UNITED STATES PATENT AND TRADEMARK OFFICE

APPLICATION NO.	FILING DATE	FIRST NAMED INVENTOR	ATTORNEY DOCKET NO.	CONFIRMATION NO.
10/594,916	09/29/2006	Tomohiro Yabu	4633-0186PUS1	5517
2292 7590 11/26/2010 BIRCH STEWART KOLASCH & BIRCH PO BOX 747 FALLS CHURCH, VA 22040-0747				
EXAMINER				
LOFFREDO, JUSTIN E				
ART UNIT		PAPER NUMBER		
3744				
NOTIFICATION DATE		DELIVERY MODE		
11/26/2010		ELECTRONIC

Office Action Summary

DETAILED ACTION

Annotated Figures

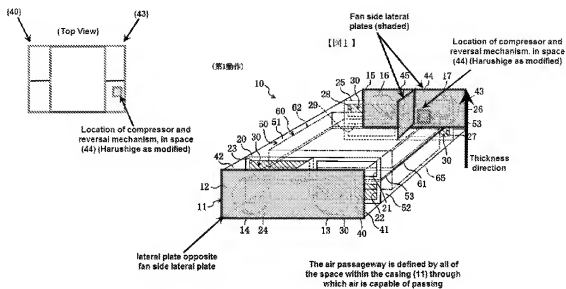
discharging the other air stream to an outdoor space, wherein: the humidity control system comprises: a refrigerant circuit (70) which includes first and second adsorbent-supported heat exchangers (62) & (65), respectively, which are both fluidly connected in the refrigerant circuit (70); a box-shaped casing (11) internally having space through which air is capable of passing (corresponding to the claimed air passageway) in which the heat exchangers (62) & (65) are disposed; an air supplying fan and an air exhausting fan disposed in the casing (11) (paragraph [0031]); change mechanisms (30) (corresponding to the claimed switching mechanism) capable of changing the distribution route of air in the casing (11) depending on the circulation direction of the refrigerant in the refrigerant circuit (70) so that the first air stream is passed through one of the heat exchangers (62) or (65) that is functioning as an evaporator while the second air stream is passed through the other heat exchanger that is functioning as a condenser; wherein the casing (11) has an internal space divided into a indoor side space (43) (corresponding to the claimed first space) defined along a fan side lateral plate as a lateral plate of the casing (11), and a center space (50) and outdoor side space (40) (which combine to make up the remaining second space as claimed) (Fig. 1); wherein first and second heat exchangers, (62) and (65), respectively, are disposed in the second space (Fig. 1); and a compressor (71) and a four-way switching valve (73) (corresponding to the claimed reversal mechanism) (see e.g. paragraphs [0007]-[0012] & [0064-0066], annotated Fig. 1; Figs. 2, 9a & 9b).

Consider claim 4. Harushige discloses that, in the casing (11), an outlet opening (14) and an inlet opening (16) are in fluid communication with the indoor space and another outlet opening (17) and another inlet opening (13) are in fluid communication with the outdoor space.

Consider claim 8. Harushige discloses that the casing (11) is shaped like a flattened box; and that the first and second heat exchangers (62) & (65), respectively, are arranged so as to allow the passage of air in a horizontal direction of the casing (11) (Figs. 1 & 2).

Consider claim 9. Harushige discloses that the casing (11) is shaped like a flattened box; and that the first and second heat exchangers (62) & (65), respectively, are arranged so as to allow the passage of air in a direction perpendicular to a horizontal direction of the casing (11) (Figs. 1 & 2).

Consider claim 19. Harushige as modified discloses that in the casing (11) the first and second heat exchangers (62) & (65), respectively, are disposed adjacently to each other and the inflow surface of the first heat exchanger (62) and the inflow surface of the second heat exchanger (65) lie on the same plane, wherein the same plane is perpendicular to the fan side lateral plate (Harushige, ann. Fig. 1; Fig 2).
